Rezoning Transportation Analysis

Petition Number: 2019-008

Date	Description
01-31-2019	First Review

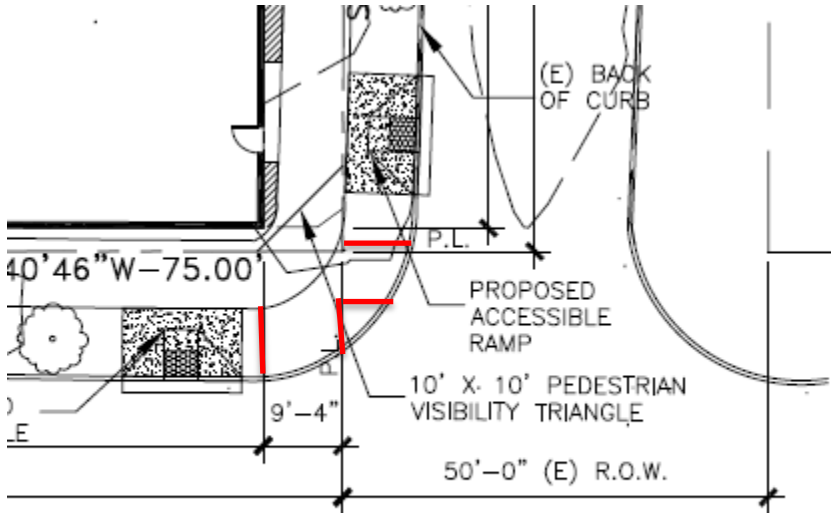
1. **Curbline** The proposed zoning district has a setback measured from back of the existing or proposed future curbline. The existing back of curb is in the correct future location for Seigle Avenue.
2. **Traffic Study** ~~A Traffic Impact Study/Transportation Technical Memorandum is not necessary for the complete review of this petition.~~

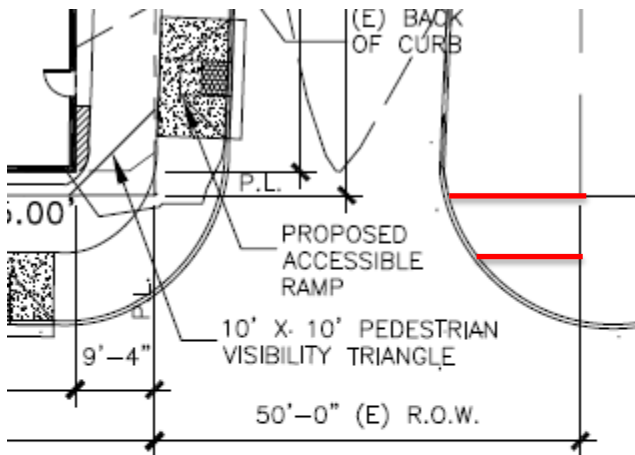
3. Seigel Avenue is an existing minor thoroughfare which requires 60' of right-of-way. This site requires 30' right-of-way dedication measured from the centerline of Seigel Avenue. The petitioner shall revise the site plan to show, label, and dimension the future back of curb from the centerline.
4. The petitioner shall revise the conditional note(s) to commit to the construction of the two ADA ramps at the corner of Seigel Avenue and East 15th Street.

5. The petitioner should rebuild the receiving ramps at the corner of Seigel Avenue and East 15th Street to meet City of Charlotte and PROWAG standards.
